AMENDMENT OF SOLICITATION/MODIFICATION OF CONTRACT				1. CONTRACT ID CODE See Block #2		PAGE OF PAGES 1 of Error! <i>Bookmarked</i>			
2. AMENDMENT/MODIFICATION NO. 007		3. EFFECTIVE DATE 27 JAN 2006		4. REQUISITION/PURCHASE REQ.NO.		5. PROJECT NO. (If applicable)

The purpose of this amendment is to answer questions and extend proposal due date.

SB01 Splice Box Enclosure - continued**specifications**

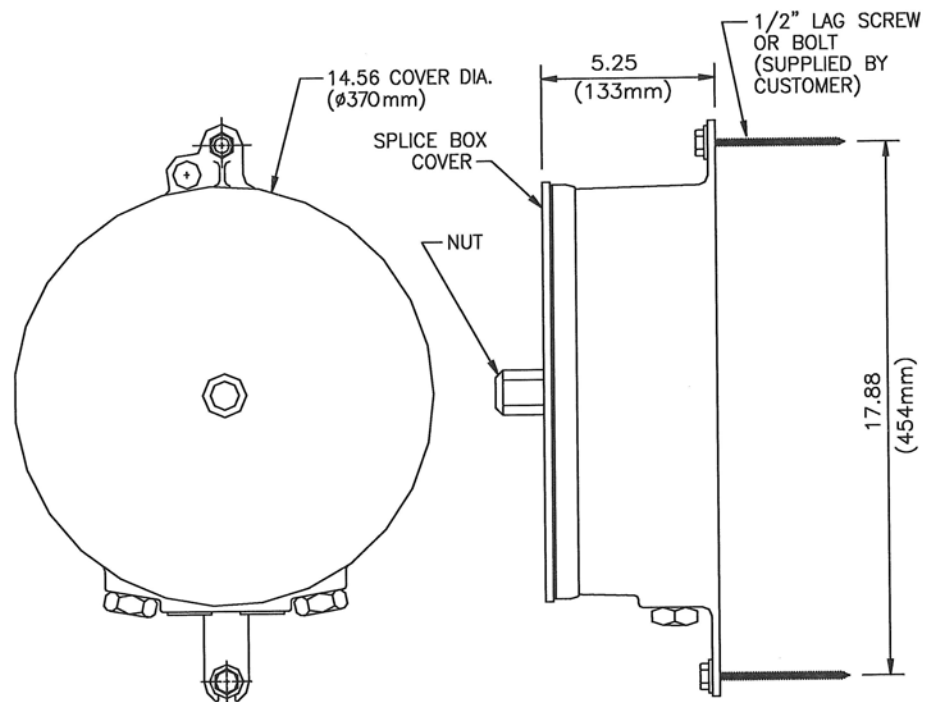
Question 2: Is there a desired size on the pull boxes for the OPGW on the 115KV dead end?

Answer: Here is the standard OPT-gw pull box from Alcoa (the typical OPT-GW provider), it is round, 18" diameter by 5 1/4" deep. This or a similar panel would be required.
